**15-BSTD-01**

**Proposed Revisions to the California Building Energy Efficiency Standards California Code of Regulations, Title 24, Part 6 and Appendices; 45-Day Language**

## **NEMA Comments on Proposed Revisions to the California Building Energy Efficiency Standards California Code of Regulations, Title 24**

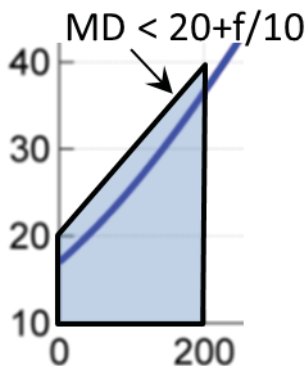
JA8's restrictions on flicker, as summarized in Table JA8, are overly restrictive for some frequencies and too lax for others. The human eye definitely does not have a flat response over the range from 0 to 200 Hz.

This specification makes no allowance for the dependence of human flicker sensitivity either on frequency or on wave shape. For sine wave modulation, the visibility threshold for stroboscopic effects, expressed in terms of modulation depth, is shown in the figure below. At a particular frequency, modulation depths above the curve can be detected by most people. Below the curve, they are not detected by most people. The threshold changes for different wave shapes, in a way that depends on the Fourier components of the light output waveform. A full Fourier approach would take account of both frequency and wave shape effects. Sensitivity to flicker also depends on the application. Flicker in outdoor street lighting or in stairwells is more tolerated than in indoor offices, for instance. Therefore, a curve of acceptability may be above the visibility threshold curve. Different curves may be needed for different applications.

Zooming in on the region from 0 to 200 Hz in the figure above (right), the blue shaded rectangular region with dashed outline represents the conditions allowed by the JA8. The red triangle is forbidden by the JA8, but flicker in this region is not visible to most observers. JA8 as a MINIMUM specification should not exclude acceptable regions where flicker is not even be detected.

If CEC is unwilling to remove the flicker specification and wait for agreement in standards organizations, then CEC should at the very least modify the present specification to allow use of the acceptable flicker region denoted by the red triangle in the figure above. We suggest modifying the specification to allow flicker in the region shown in the figure below. The specification would then be:

“Dimmer controls that can directly control lamps shall provide electrical outputs to lamps for reduced flicker operation through the dimming range so that the light output has an amplitude modulation below the line,  $\text{Modulation Depth} = 20\% + \text{Frequency}/10$ , for frequencies from 100 to 200 Hz, without causing premature lamp failure.”
